Item 14.**Development Application - 205-213 and 215-225 Euston Road, Alexandria - D/2018/907****File No.:** D/2018/907**Summary**

Date of Submission:	8 August 2018 Amended plans and information received 15 November, 2 December, 19 December and 20 December 2019
Applicant:	Hailiang Property Group Australia
Architect/Designer:	Silvester Fuller, MHNDUnion and Sue Barnsley Design
Developer:	Hailiang Property Group Australia
Owner:	Maxida International Alexandria Property Australia
Cost of Works:	\$234,680,600
Zoning:	B4 Mixed use
Proposal Summary:	<p>The proposal is a detailed design development application (stage 2). It seeks consent for the construction of eight mixed use buildings comprising 389 residential apartments, office and retail uses and two basement levels.</p> <p>The application is to be determined by the Central Sydney Planning Committee (CSPC) as the cost of works exceeds \$50 million.</p> <p>The proposed development is also Integrated Development under the Water Management Act 2000 and the Roads Act 1993.</p> <p>The development site is subject to a concept consent (D/2016/989/A) which approved eight (8) mixed use building envelopes for residential, retail and commercial

Figure 22: South elevation of building H (Parkside buildings). The yellow line shows the approved concept envelope and the red dashed line shows the 18 metre height limit.

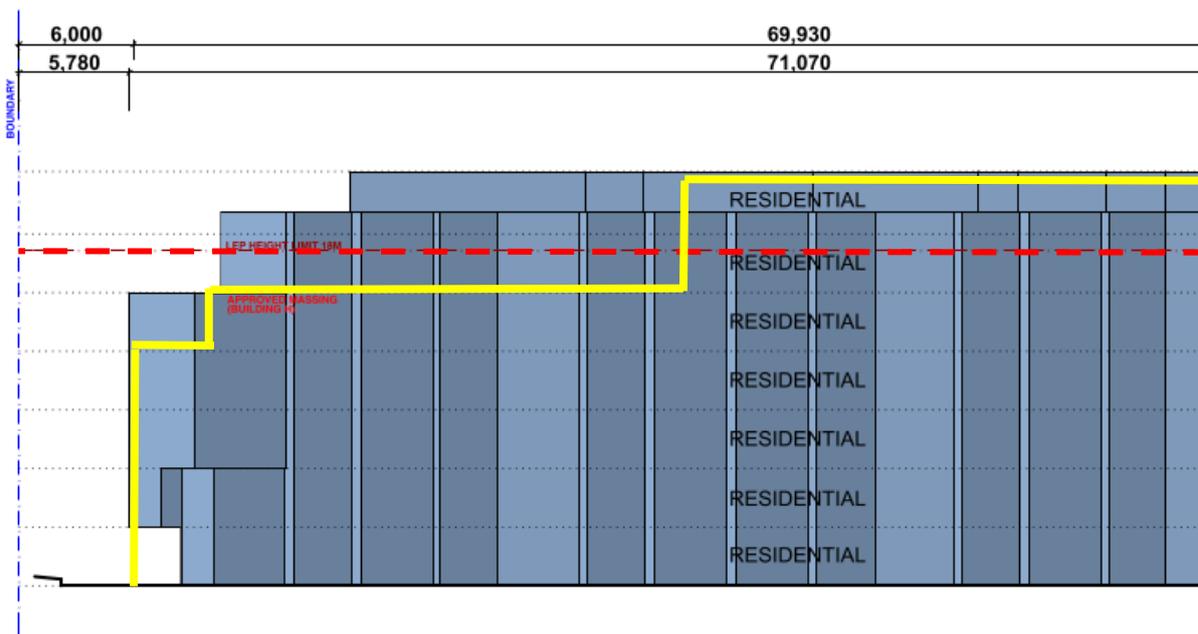
The below plan indicates the extent of the breach of the height limit proposed by the development.

133. The setbacks of the upper levels are shown in figures 22 to 30 above. These show that the concept envelope required upper level setbacks to the Park (in exchange for additional height on the Euston Road side of the site) and that these setbacks have been disregarded in the subject proposal.

Figure 27: Comparison of approved (white) and proposed massing (red) showing how the Parkside and Euston Road buildings are taller, protruding closer to the boundaries and will be more visible from Sydney Park.

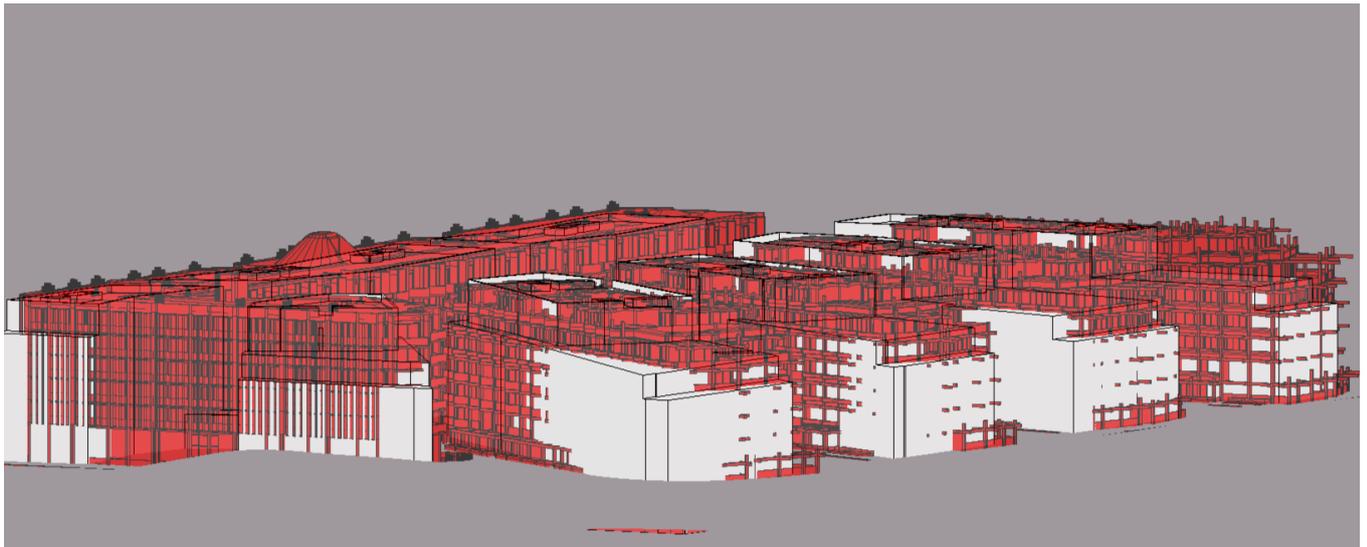
128. The figures below were prepared by the City's Modellers using the 3D models submitted by the applicant. These demonstrate how the detailed DA (shown in red) is proposed to be significantly larger the original approved concept envelope (shown in white). These changes result in significant adverse impacts for Sydney Park.

Figure 31: Proposed ground floor southern side of site adjoining Sydney Park, reduced to a minimum of 1.5m.

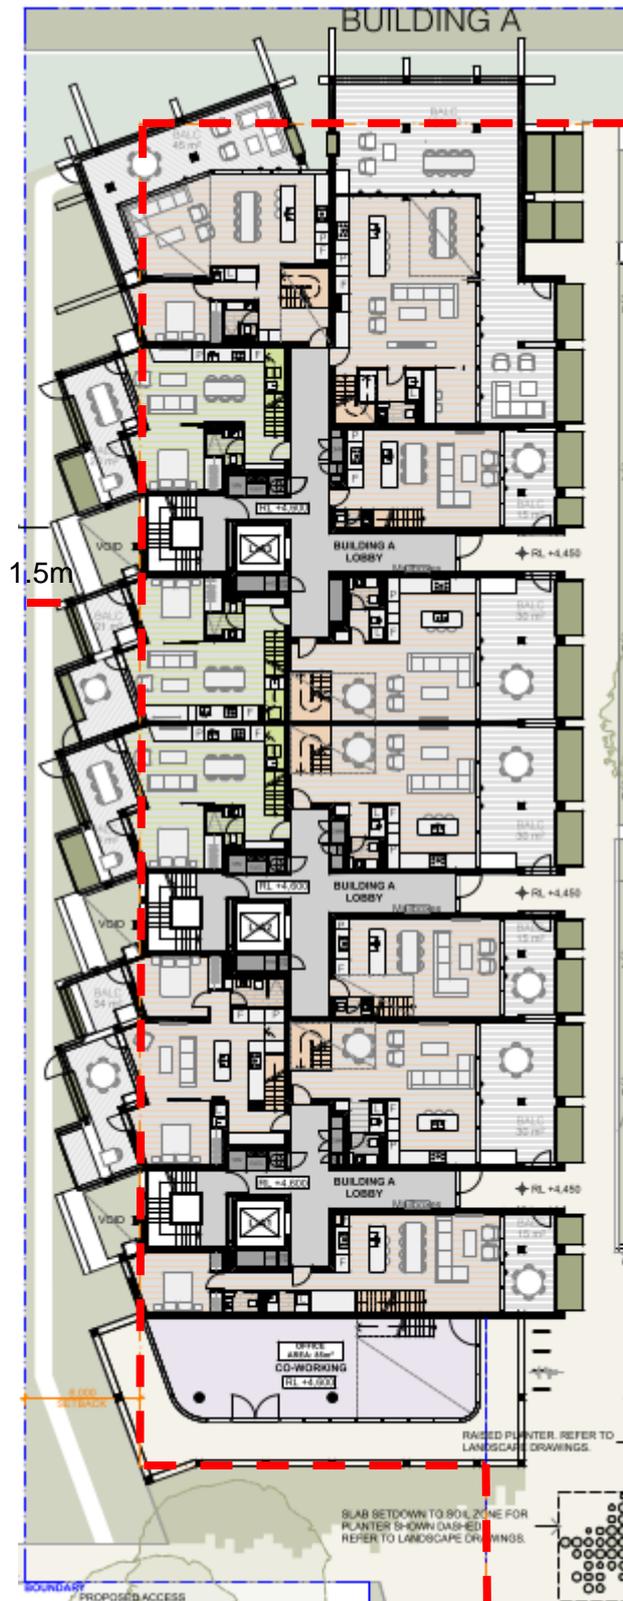
131. The proposed development seeks consent for;
- (a) 1.5m ground floor and basement setbacks to the park on the southern boundary;
and
 - (b) 1.2 to 3.5 metres to the park on the western boundary.

132. This is shown in the figures below.

Figure 38: Shadow diagram at 12pm. Orange shows additional shadow and green shows shadow reduction. This plan does not include balconies, pergolas or additional structures.

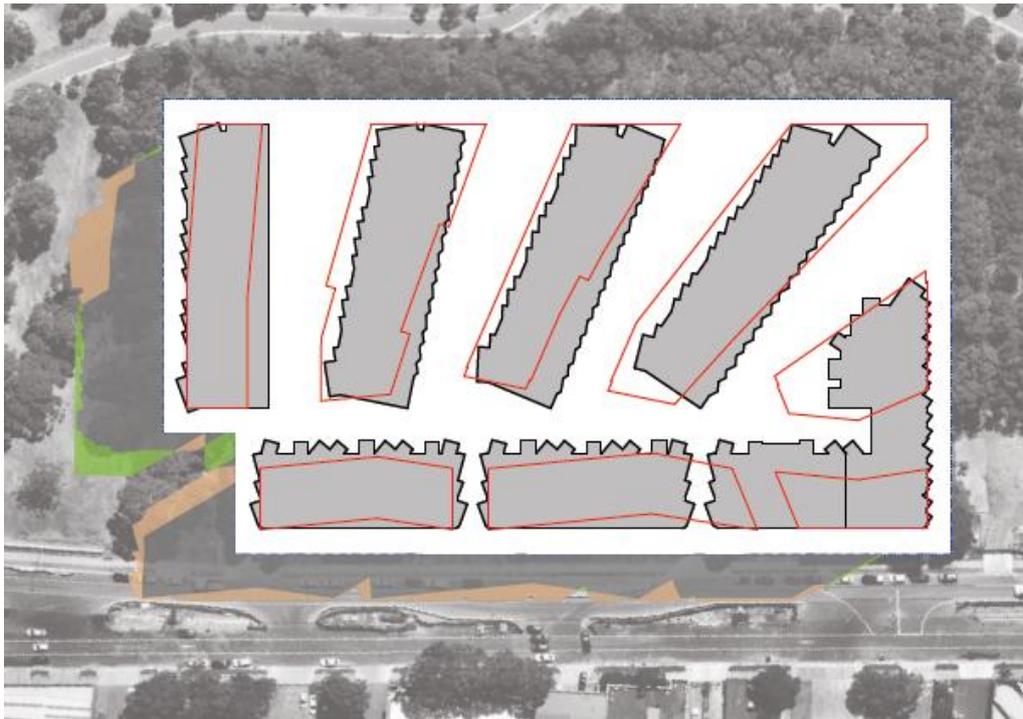
143. The part of the park which will be overshadowed between 9am and 3pm is included at figure 40 below. This includes a number of trees and a walking path which connects Euston Road to the internal walking path within the Park.

Figure 44: Level 4 plan marked up showing separation distances non-compliances between studio apartments. These should be separated by a minimum of 12 metres.

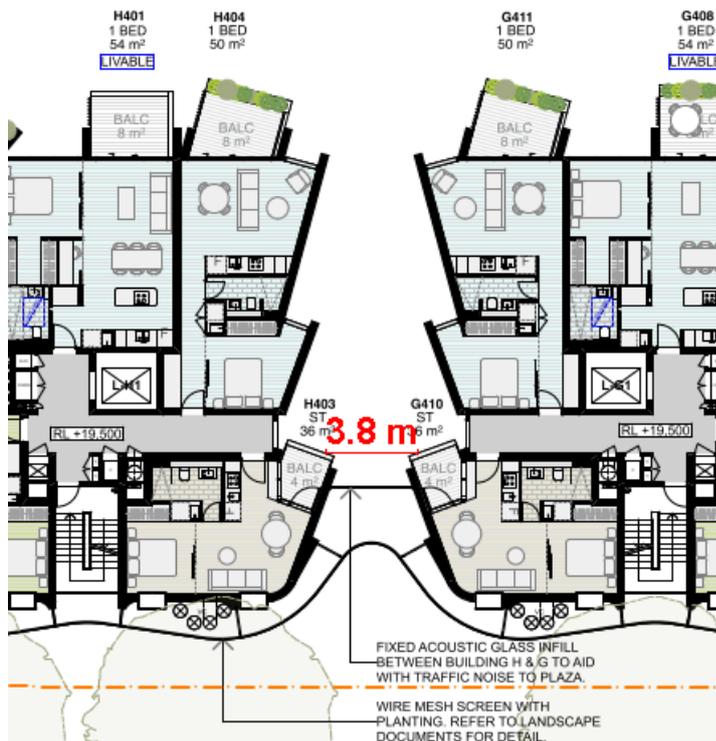
171. The development does not provide the minimum separation distances required by the ADG. On level 4 between the Euston Road buildings and the eastern end of the Parkside buildings, the minimum separation distance should be 18m. As per the below figure, at the closest, the buildings are only 8.6metres apart.

Figure 45: Proposed access to the site.

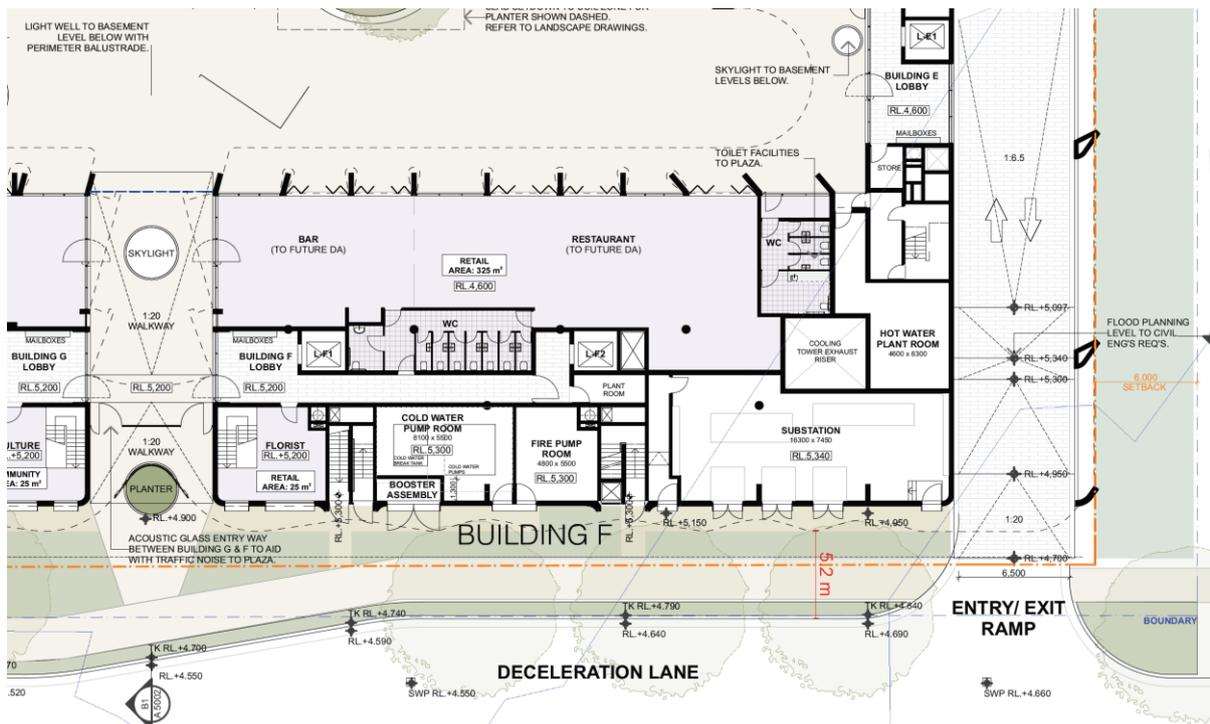
174. Condition 19 on the concept DA requires the following:
- (a) a 3.5m path with verge to be maintained along the Euston Road frontage in the development and competition phase and lodgement of any stage 2 DAs. Any realignment of the property boundary to facilitate the footway resulting from the proposed deceleration lane works must be dedicated as road to the RMS (i.e. the property boundary would likely need to be deviated to accommodate the 3.5m wide path on Euston Road). This should be shown in the plans.

175. The requirements of condition 19(a) have not been met and no further detail above that which was already demonstrated in the concept DA has been provided.

176. While the plans notate a deceleration lane, paragraph 4.9.2 of the submitted SEE says "it is noted that the deceleration lane does not form part of this application and will be subject to separate detailed design and approval by RMS." In addition to this comment, no detailed drawings of the deceleration lane have been submitted.
